Long
Island
Power
Authority

LSNRC-2045

Additional Information and Clarification
as Requested by Staff Regarding the
Decommissioning Project Termination Survey Plan
Shoreham Nuclear Power Station - Unit 1
Docket No. 50-322

ENCLOSURE 3

DATA EVALUATION - UNAFFECTED AREAS

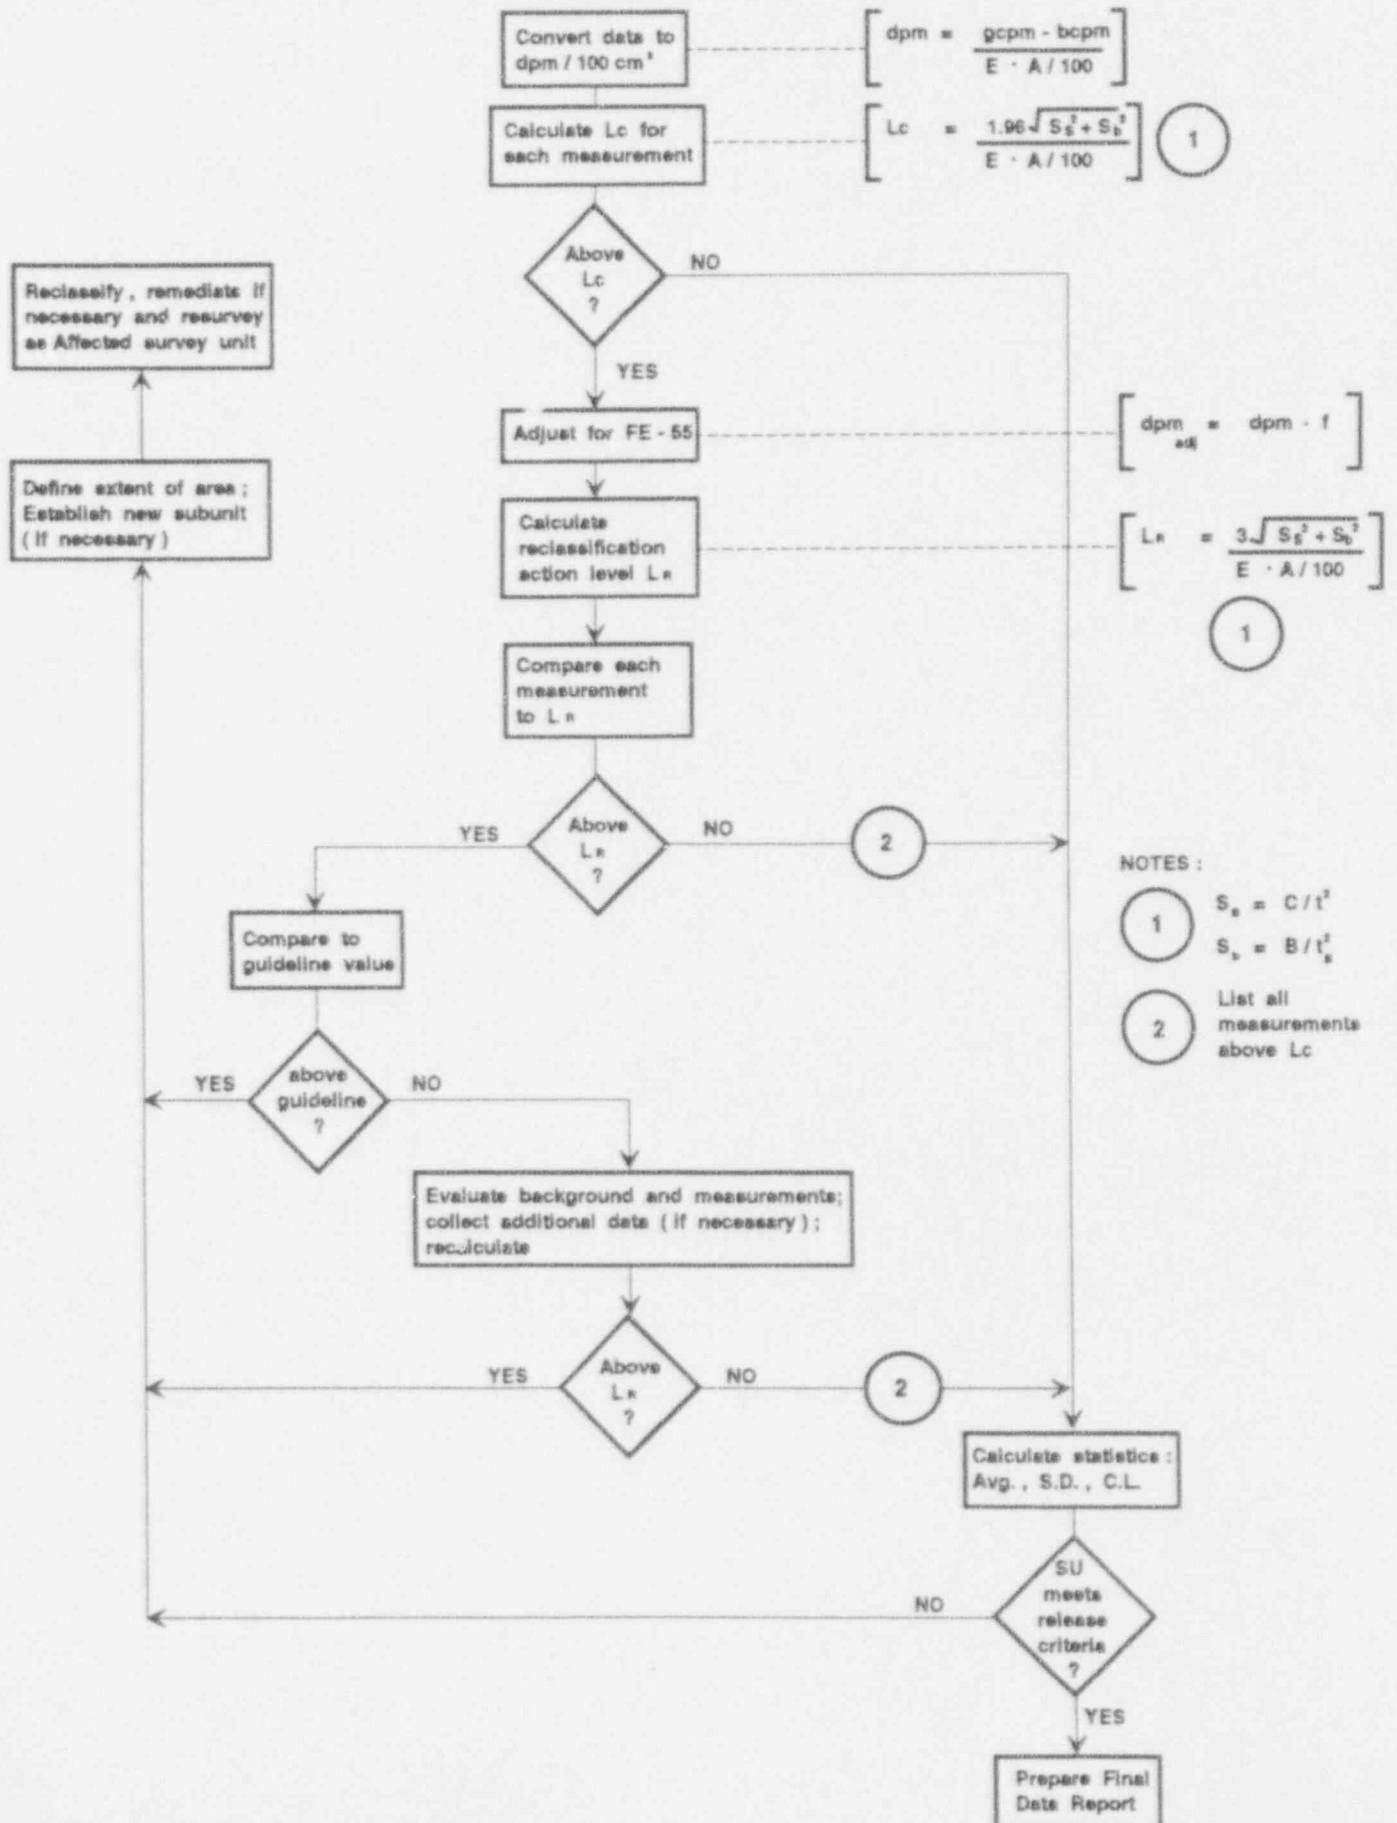
NRC Comment: The NRC Staff does not agree with the LIPA proposal to use 50 % of the 5,000 dpm/100 cm² guideline value for direct beta-gamma surface contamination measurements as the action level for investigation (and potential reclassification) in unaffected areas. An action level has been suggested which is similar to the critical level concept, but at a higher probability level, perhaps three or four sigma. Please provide a definition of the proposed action level and explain how it will be implemented.

LIPA Response: LIPA will calculate an action level, L_R , for direct beta-gamma measurements and use it to screen each measurement which has been flagged as being above background as described in response No. 4 above. This action level is defined as:

The attached flow chart summarizes the data evaluation process for unaffected survey units. It shows how the data are evaluated and screened against the critical level and the action level. It identifies the actions taken when measurements exceed the action level, including reclassification and resurvey if required. It should be noted that LIPA has previously agreed to the use of an action level of 25% of the guideline values for all other measurements of surface contamination, i.e., removable beta-gamma, removable alpha and direct alpha, and intend to retain this aspect of the survey program.

DATA EVALUATION - AFFECTED AREAS

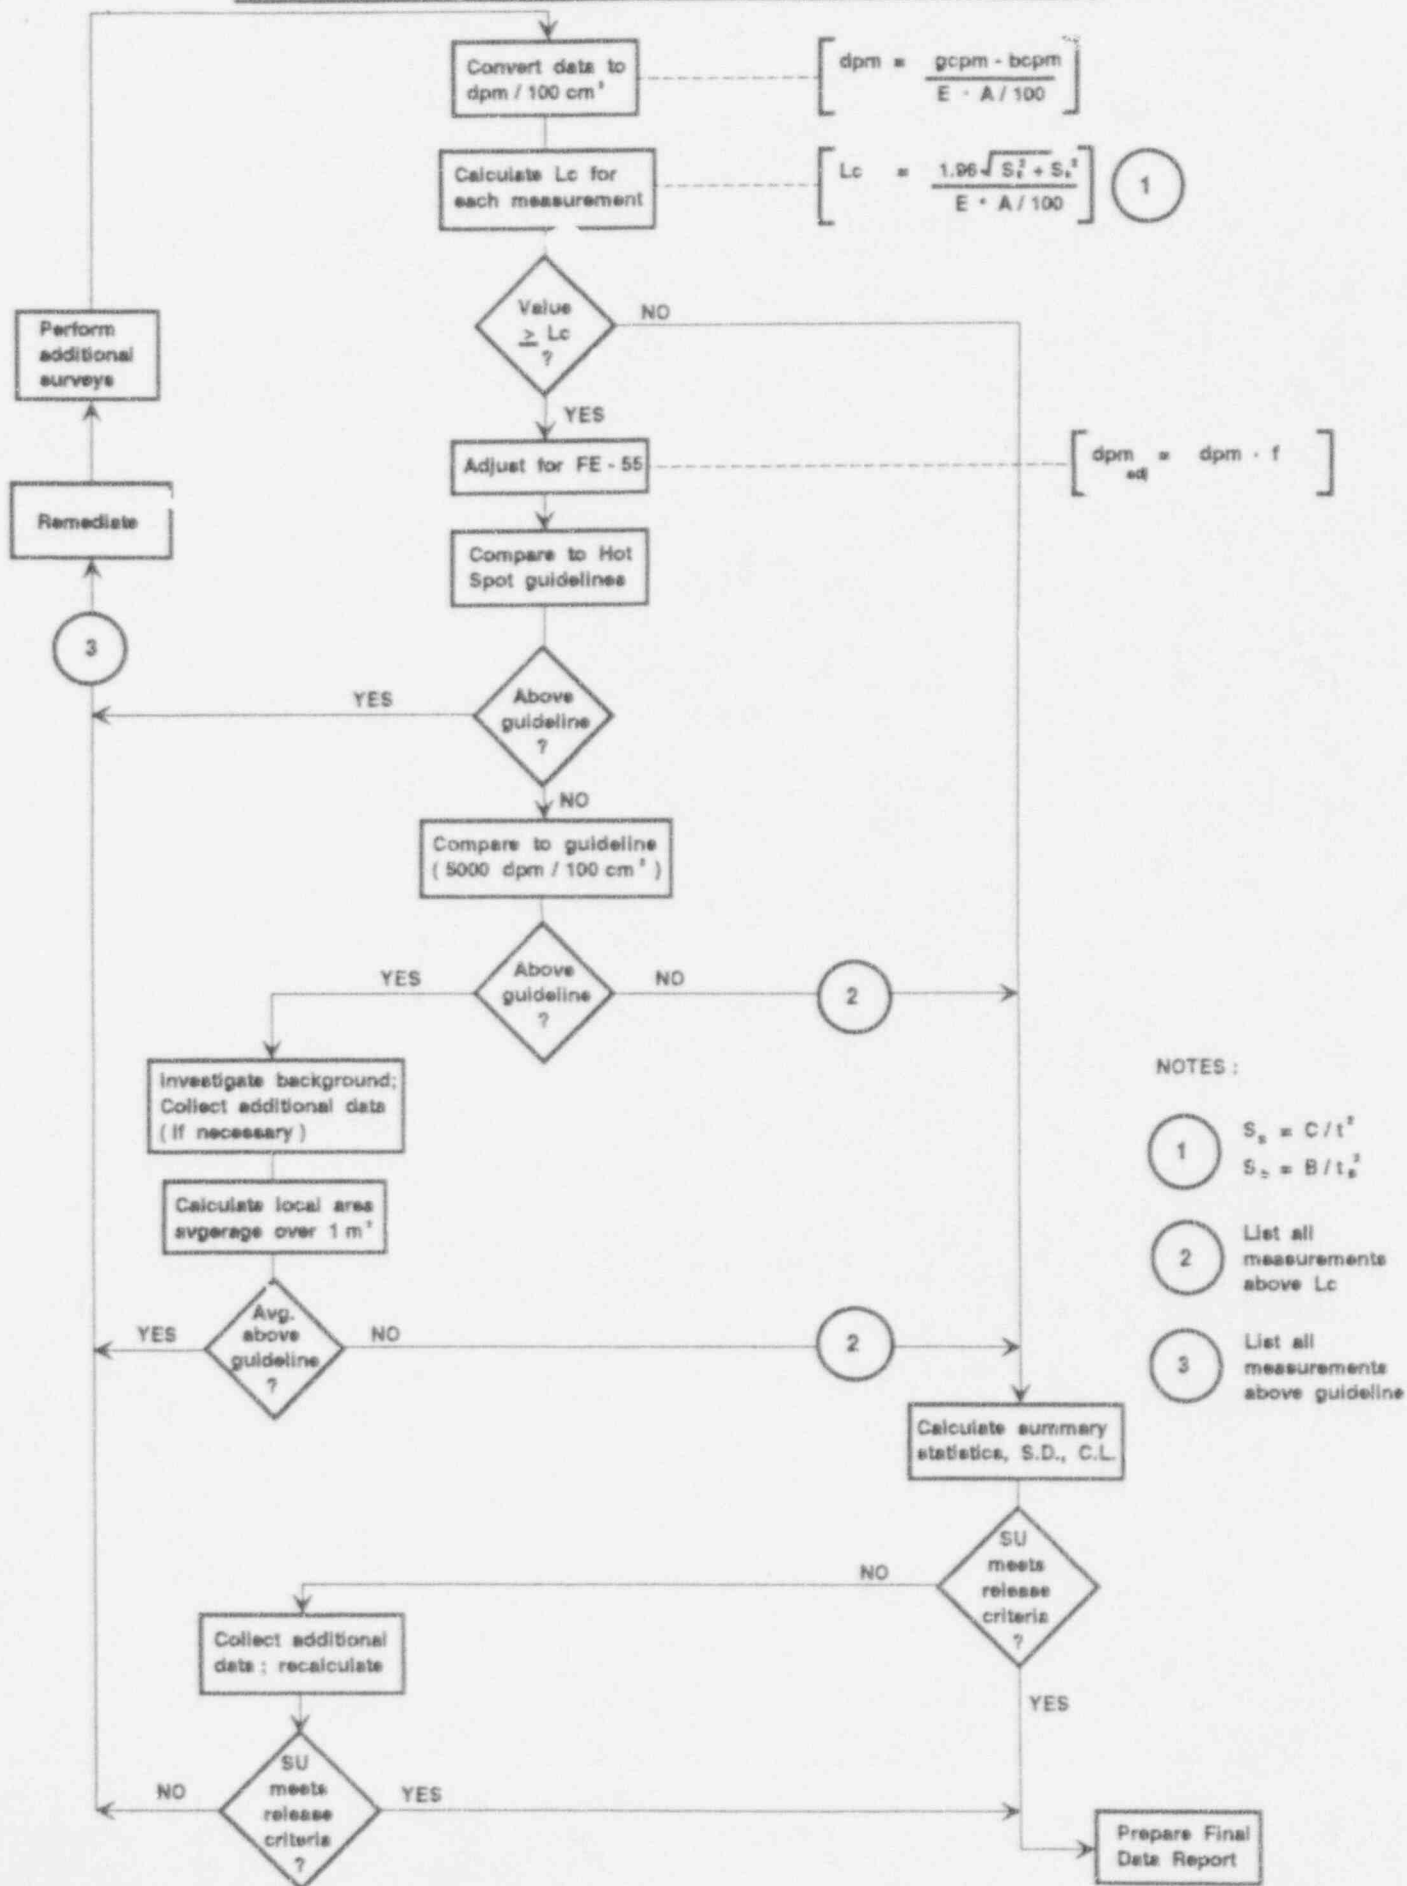
NRC Comment: Please identify in the Release Record data report for each survey unit, all instances where individual surface contamination measurements are above guideline values in affected areas. Summarize the investigation and show the evaluation to determine if the local area average exceeds the guideline value. For any cases where the guideline value is exceeded, describe the remediation and present the results of the resurvey which demonstrates that the release criteria have been met.

LIPA Response: LIPA will identify in the Release Record data report for each survey unit, all instances where individual surface contamination measurements are above guideline values in affected areas. The Release Record will summarize the investigation and the evaluation to determine if the local area averages exceed the guideline value. For any cases where the guideline value is exceeded, the remediation will be described. Results of the resurvey will be presented to demonstrate that the release criteria have been met. The attached flow chart summarizes the data evaluation process for affected areas. It shows the identification of all measurements above the critical level. It includes the screening of each measurement against the elevated level guideline and the average guideline values, and the response when measurements fail the test.
